**SANTA CLARITA VALLEY WATER AGENCY
NOTICE TO PLANHOLDERS**

ADDENDUM NO. 1

Project: T7, U4, U6 Wells PFAS Treatment, Saugus 1 and Saugus 2 Wells VOC Treatment and New Disinfection Facility Project

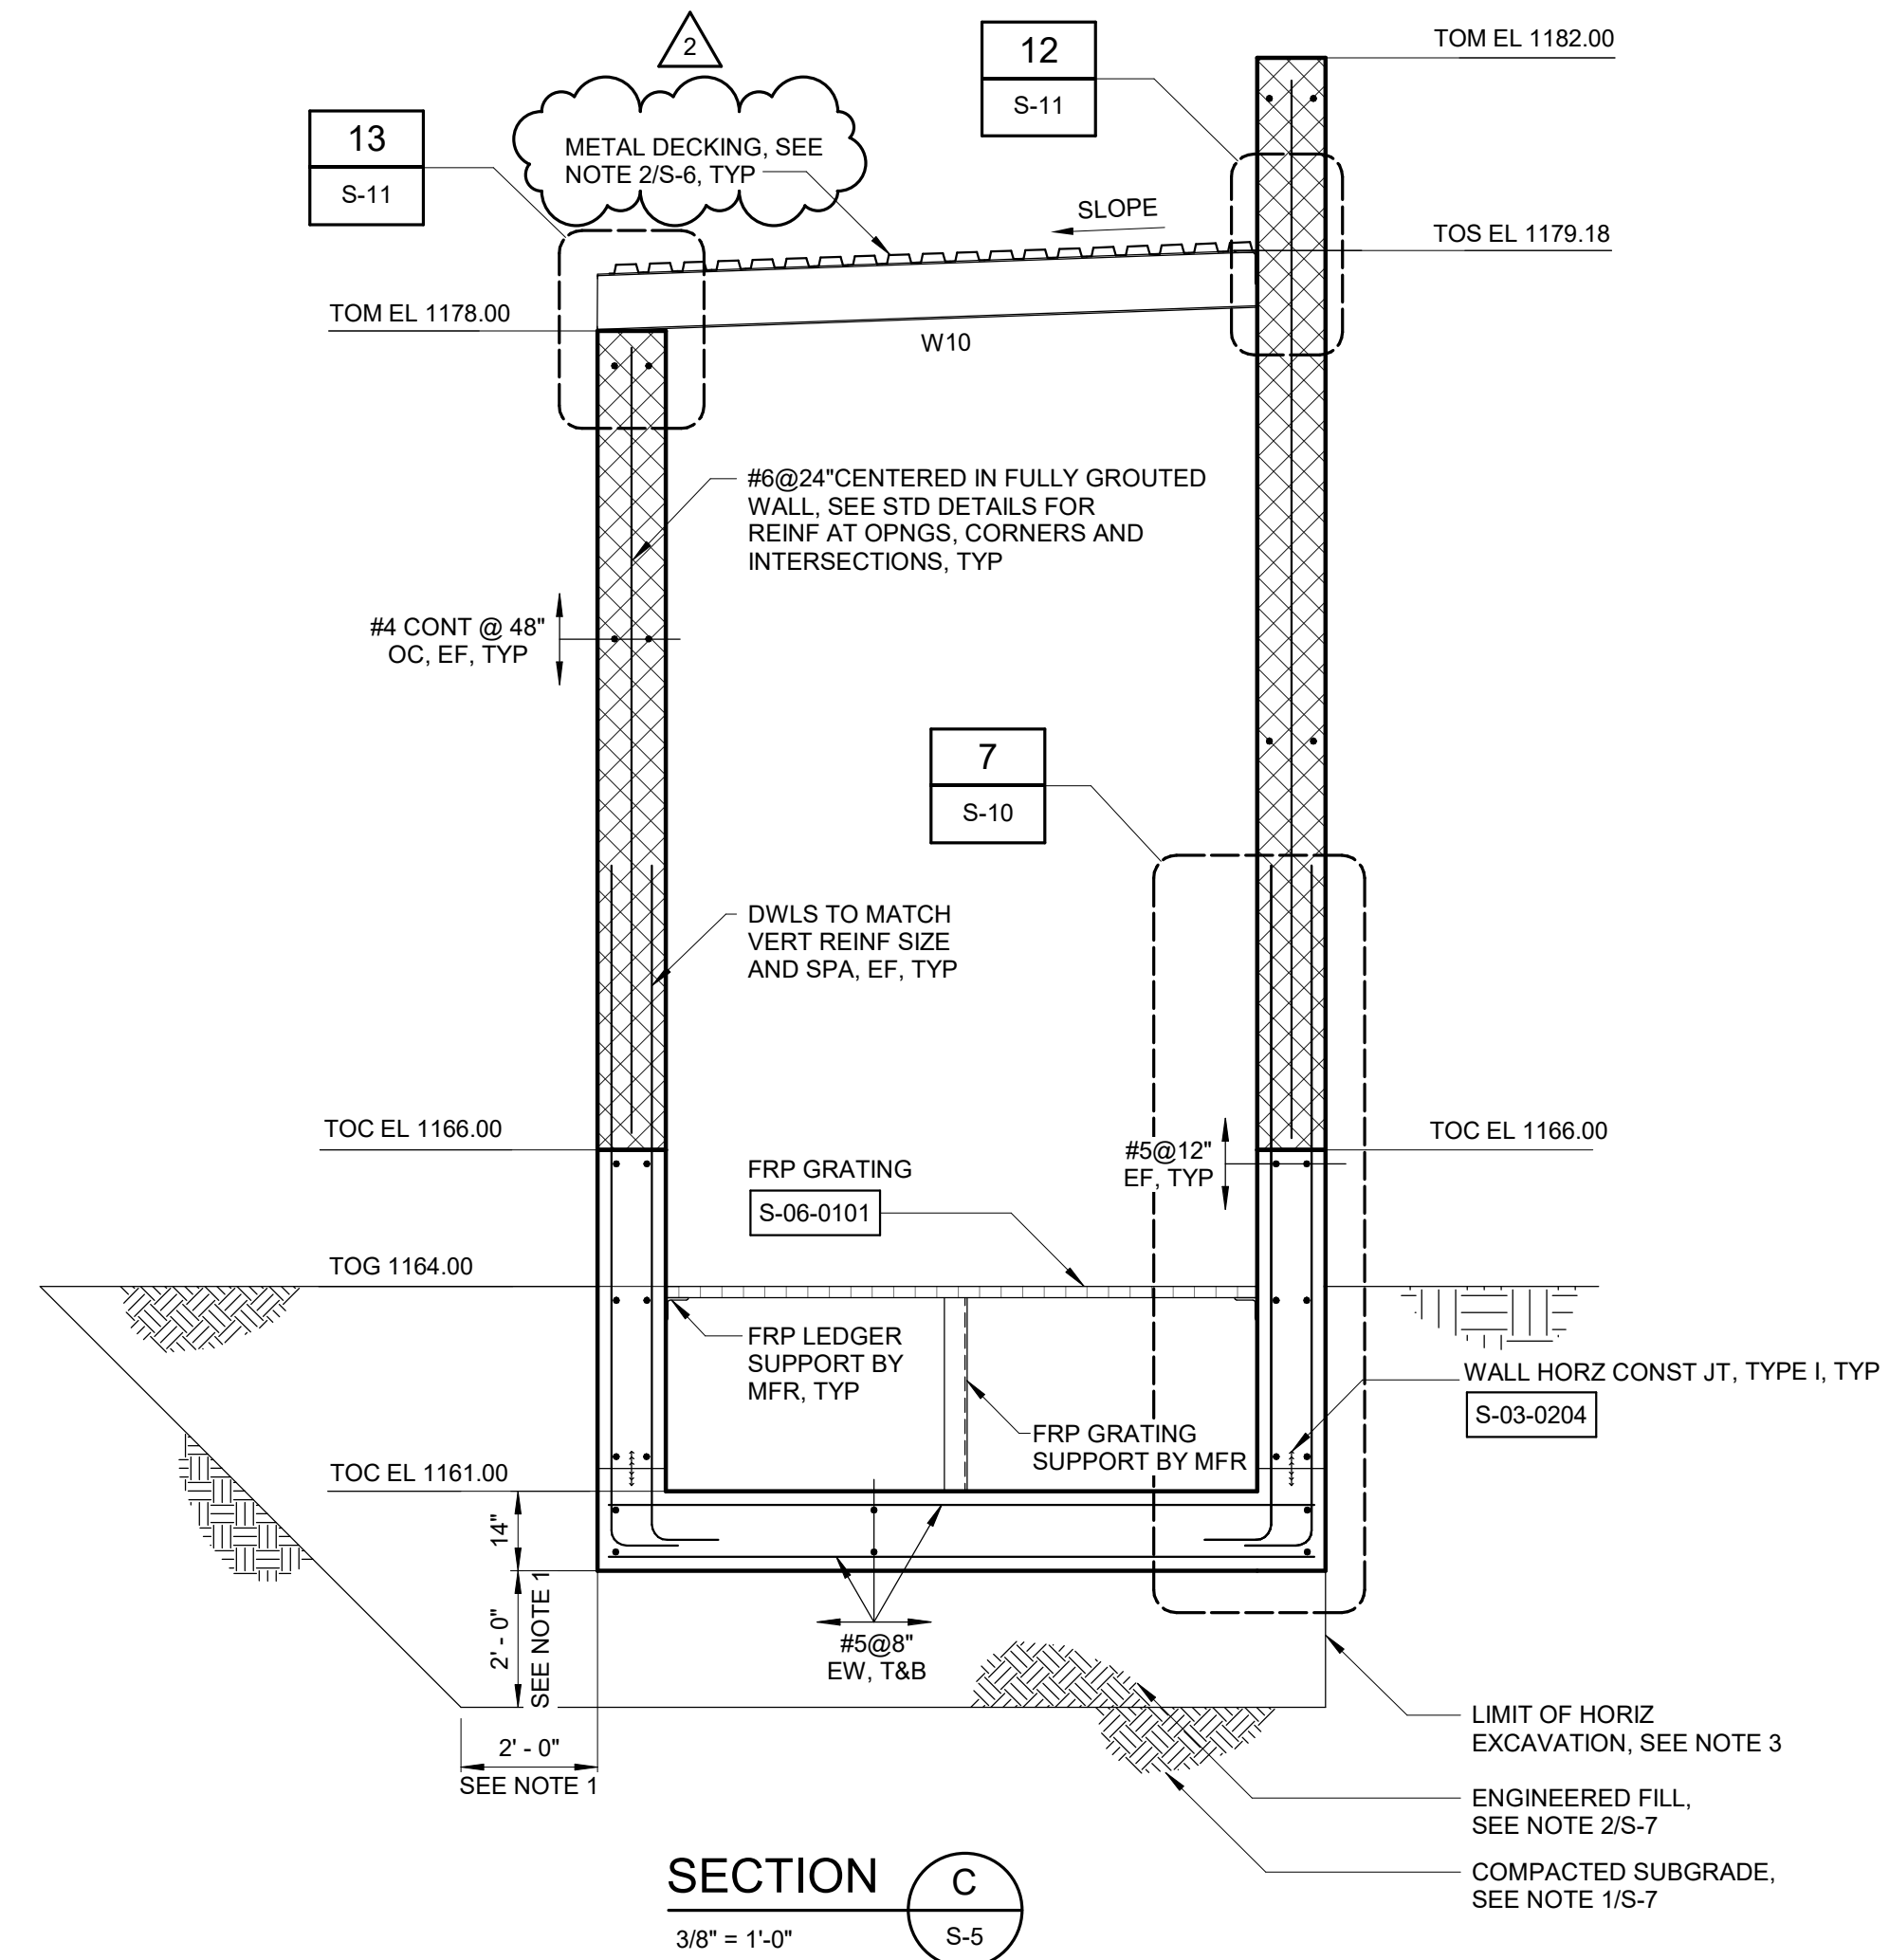
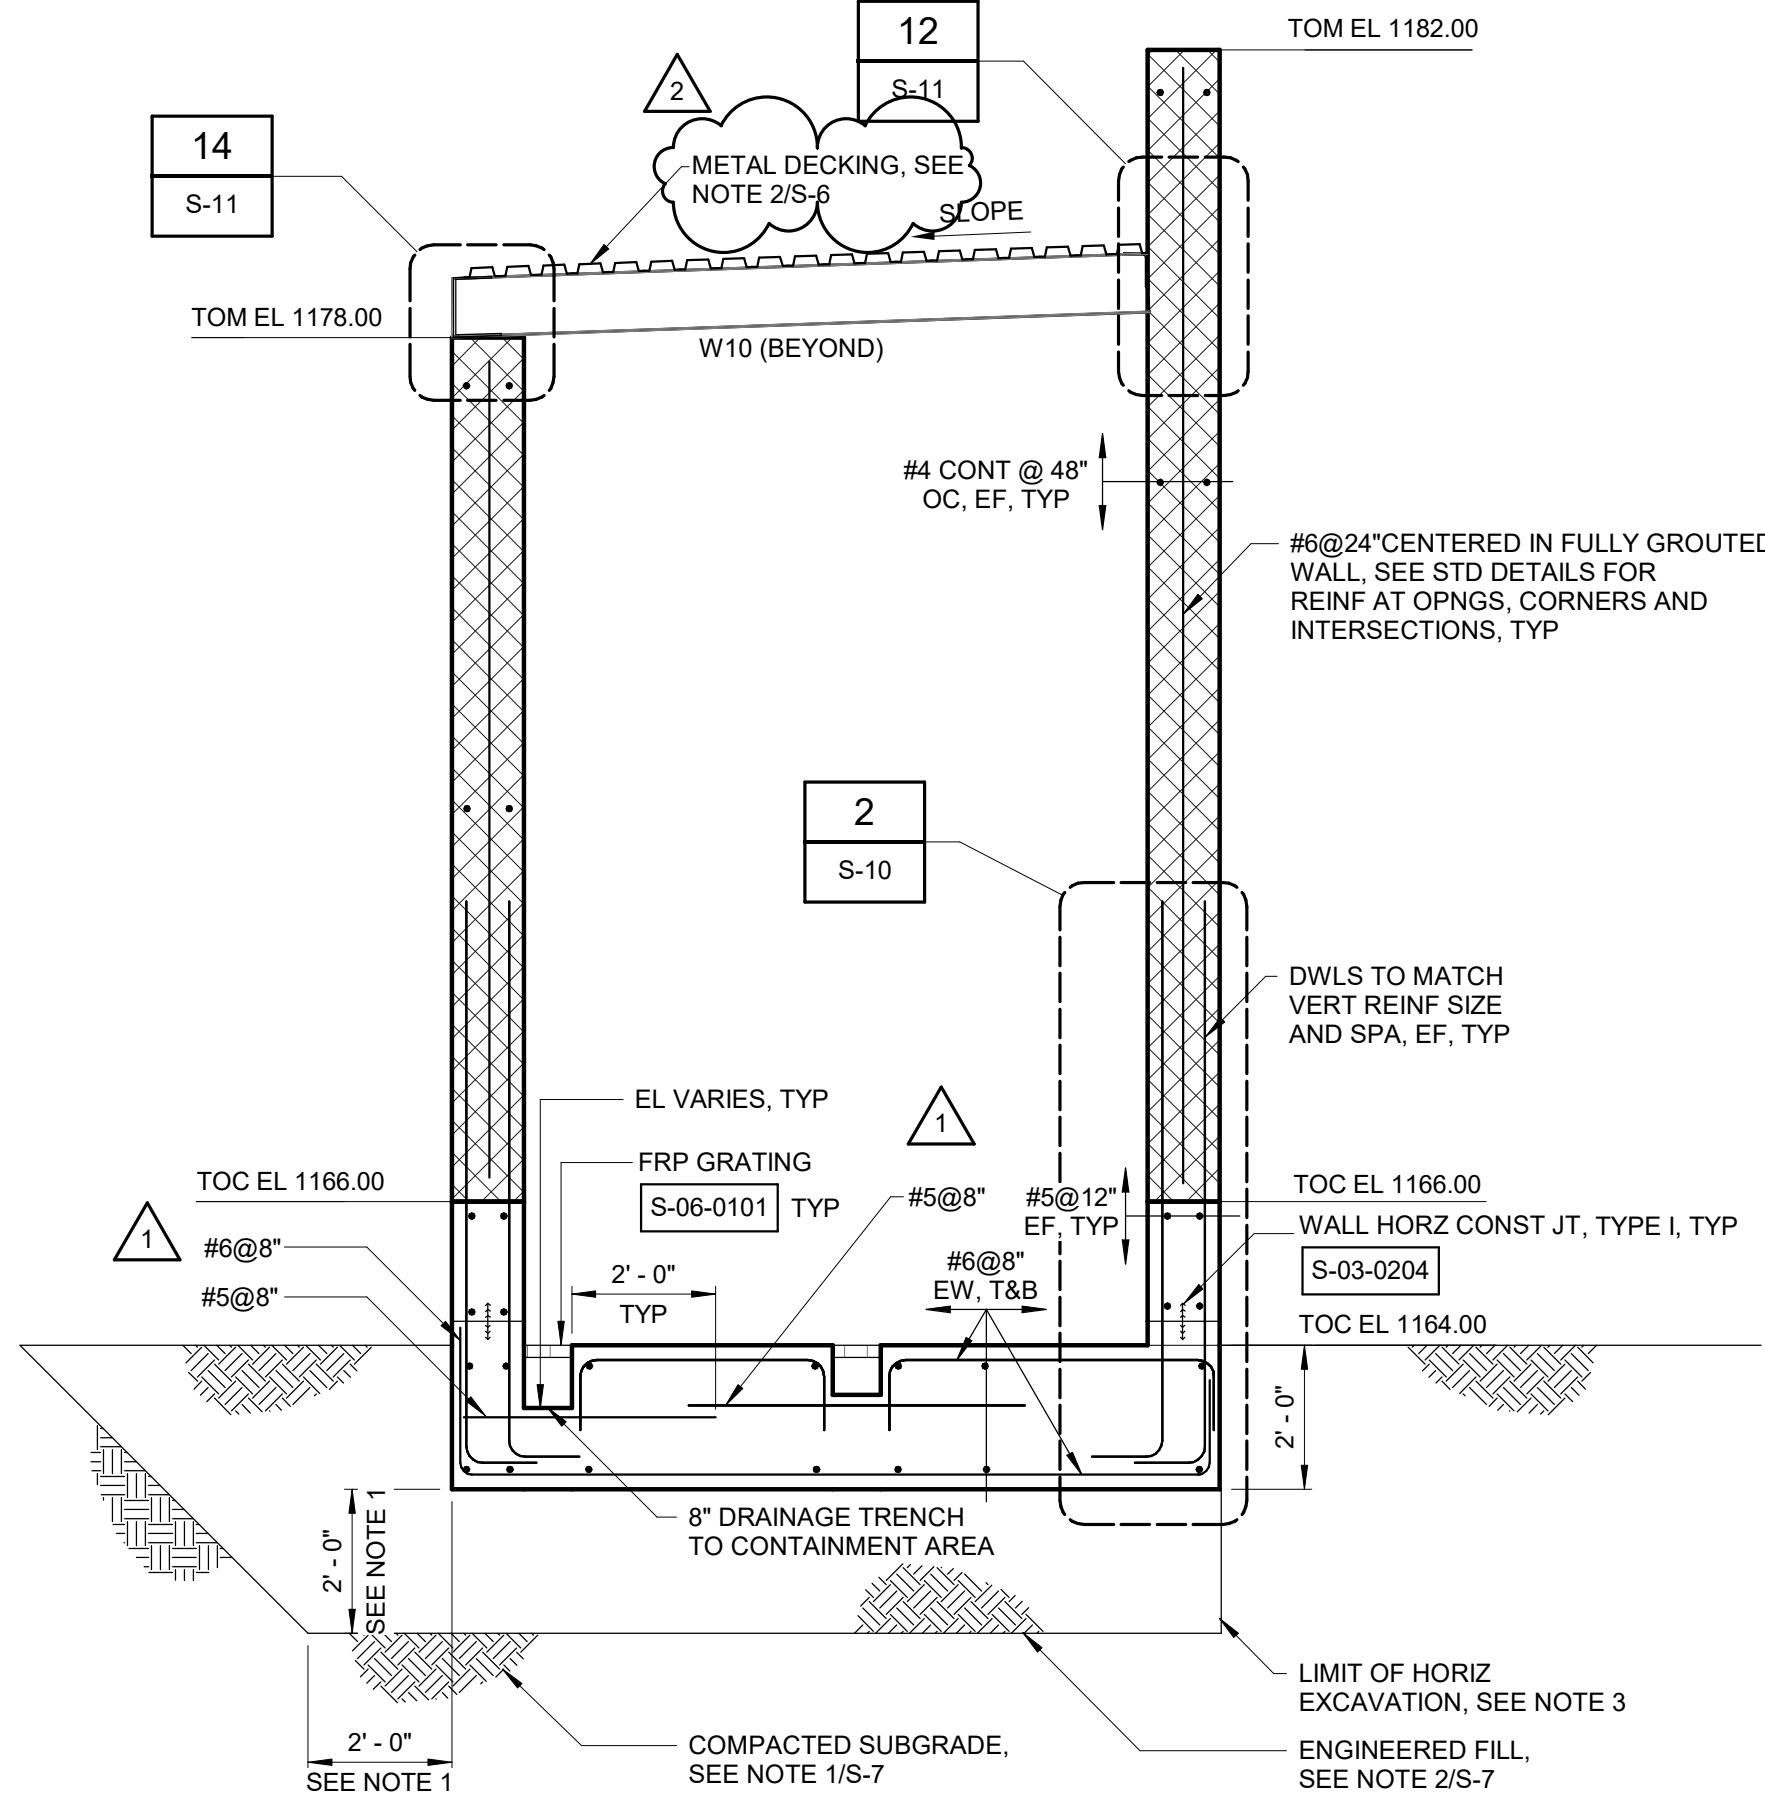
REPLACE Drawing S-7, S-9, and S-13 with the REVISED drawing attached.
